SUBJECT: COMANCHE PEAK STEAM ELECTRIC STATION
DOCKET NOS. 50-445 AND 50-446
CABLE TRAY HANGER INFORMATION

Attached for your use are EBASCO's responses to questions discussed at the February 13, 1986, NRC audit of the cable tray design verification program conducted at EBASCO's New York office. Attachment 1 summarizes the responses and action items and Attachments 2 to 10 are related documents requested from EBASCO.

NRC AUDIT OF EBASCO
COMANCHE PEAK SES CABLE TRAY HANGERS
FEBRUARY 13, 1986
EBASCO RESPONSES TO NRC QUESTIONS (SET A)

2-C6x8.2 Composite section

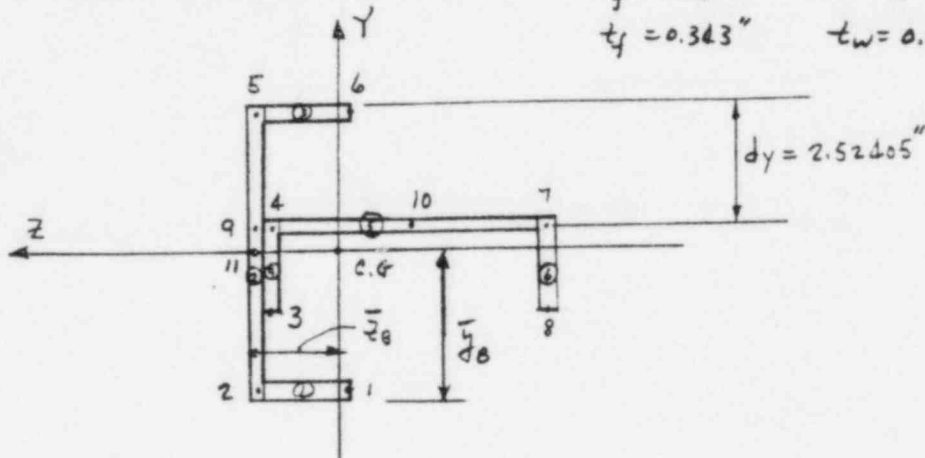
Although the shear center computations are verified by hand computation, it would be desirable to show more detailed computations of the shear flow, i.e., not only the shear flow in the flanges but also those in the web.

computing the shear flow in the web will no doubt provide a deeper insight into this problem. This calculation can be very tedious, especially for the unsymmetrical composite channels we are currently dealing with. For the case with $I_{yz} = 0$, the problem is greatly simplified. The example used in the verification by hand calculation (Vol I, Book 5, Section I) was recalculated, but with shear computations in the webs included. The shear center results are the same, and the web shear flows are shown for information and demonstrate force balance. This calculation is available and will be added to Book 5.

Ebasco will add the calculation noted above to Book 5, and provide same to TUGCO for distribution to interested parties.

SUBJECT "WARPCC" program verification

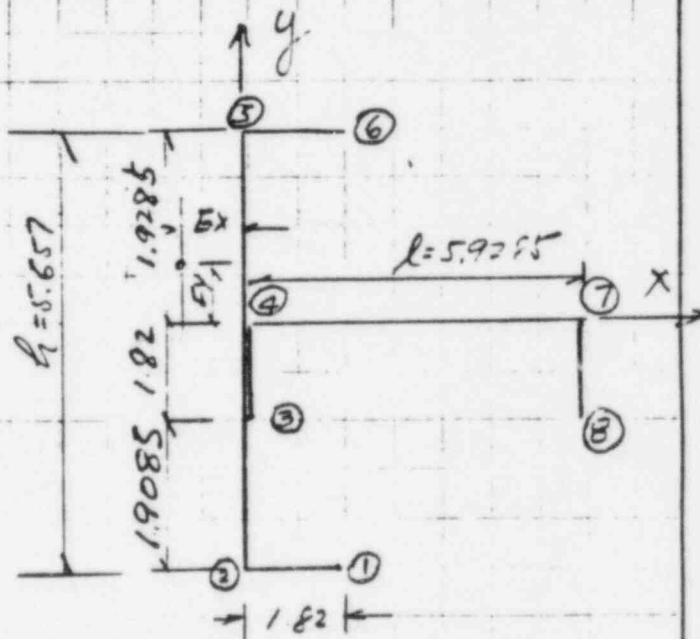
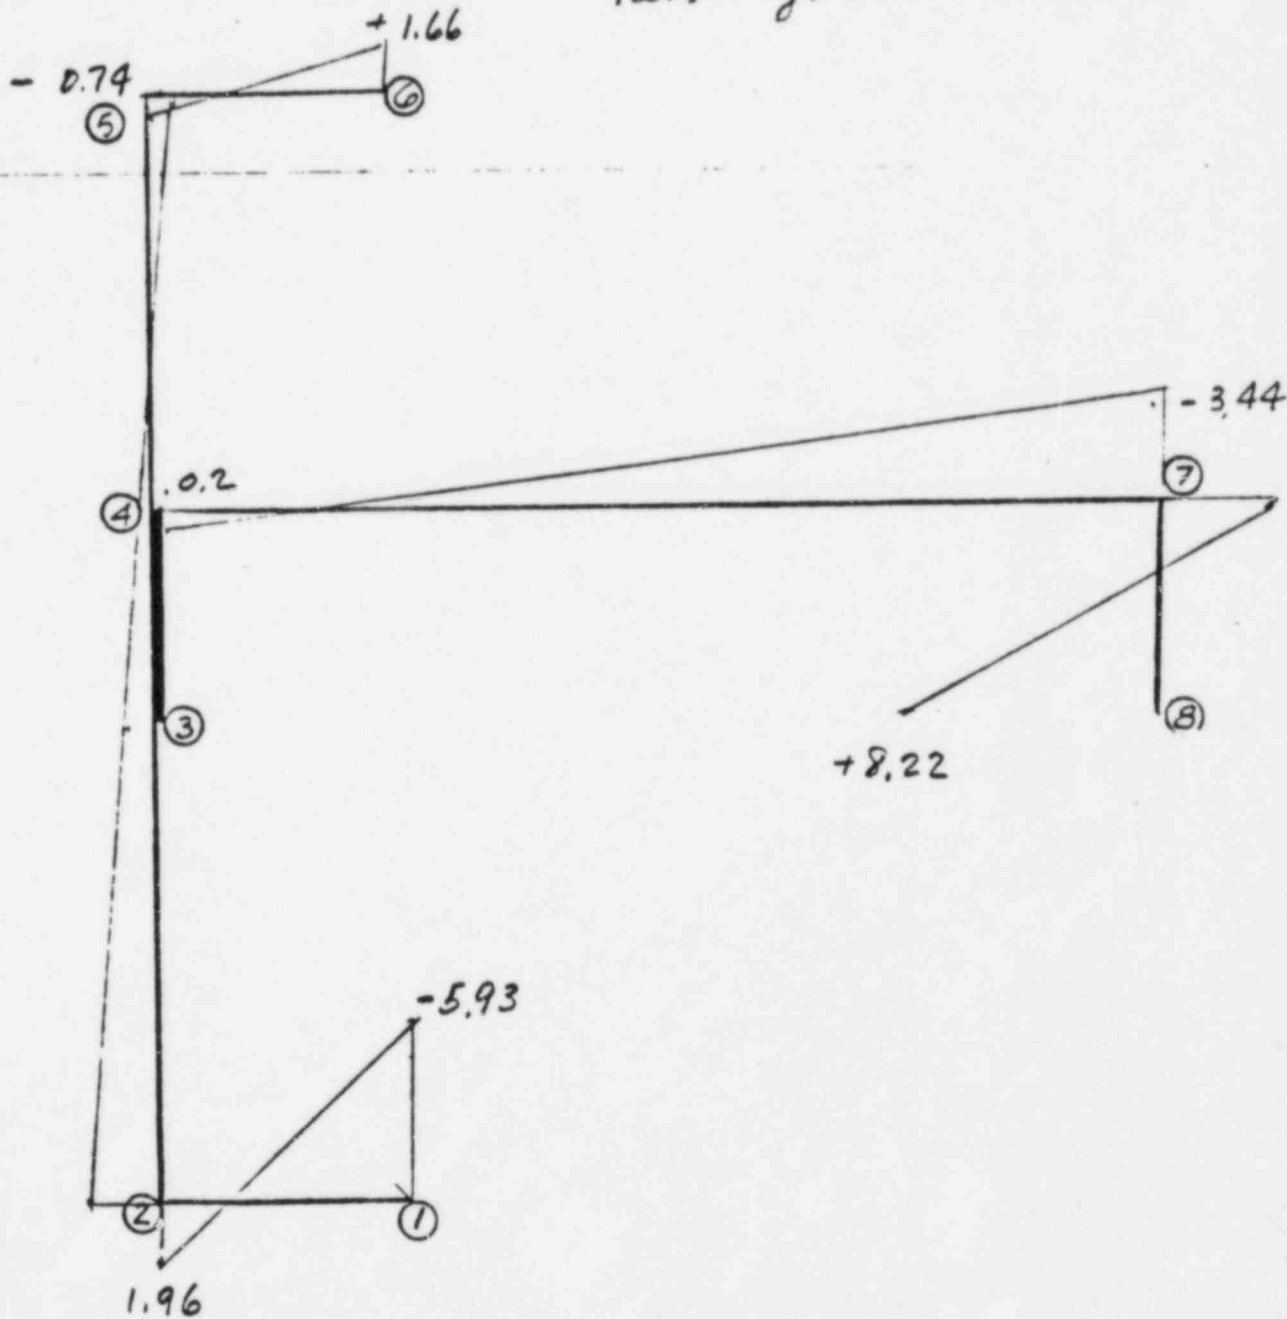
In Section III, the computer code for computing torsional constraints for the composite channels should be described in detail. A detailed hand computation of these properties to verify the computer results would also be desirable.

Ebasco will incorporate the above documentation for the "WARPCC" computer program into Book 2, and provide same to TUGCO for distribution to interested parties.
